**PLANNING DIVISION  
STAFF REPORT**

**Board of Adjustment**

**April 7, 2021**

CASE No.: <b>BOA20-00779</b>	CASE NAME: <b>Stalwart Housing DIP</b>
------------------------------	--

1,200-foot buffer current  
aerial photo

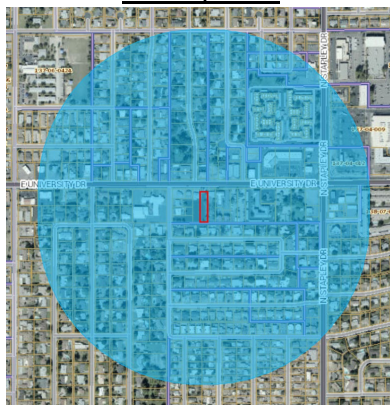
C. SURROUNDING DEVELOPMENT. The parcel is surrounded by properties within a 1,200-foot radius in which:

1. The total developable land area is not more than 25 percent vacant; and
2. Greater than 50 percent of the total number of lots or parcels have been developed 15 or more years ago.

**Based on current aerial photography, less than 25% of sites within the 1200-foot radius of the property are vacant. Comparing the 2006 Maricopa County aerial photo with the current aerial photo, it shows more than 50% of the total number of lots were developed more than 15 years ago.**

***The request complies with this criterion.***
